**Summary of Amendments to the Design Manual: Barrier Free Access 2008
(October 2020)**

Amendments to the Design Manual: Barrier Free Access 2008

(October 2020)

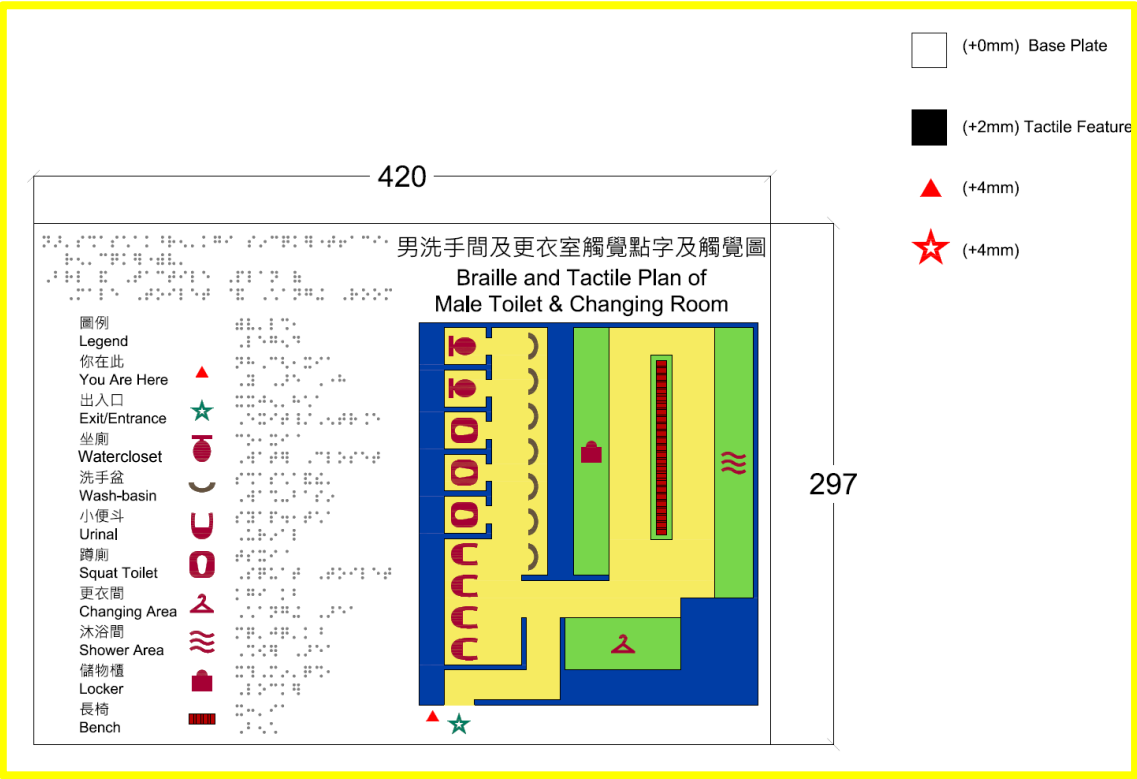
Item	2008 version	Amendments
6. Section B in Division 10 of Chapter 4*		<p data-bbox="936 188 1980 225"><i>To add a heading, paragraph (k) and Figure 23A after paragraph (j) in Section B</i></p> <p data-bbox="936 252 1162 288">Door Thresholds</p> <p data-bbox="936 316 2130 384">(k) Door threshold (see Figure 23A) should have a bevelled and round edge on each side at a gradient not steeper than 1:2.</p> <div data-bbox="936 453 2087 762" style="border: 2px solid yellow; padding: 10px;">  </div> <p data-bbox="936 820 1503 857">Figure 23A – Example of Door Threshold</p>
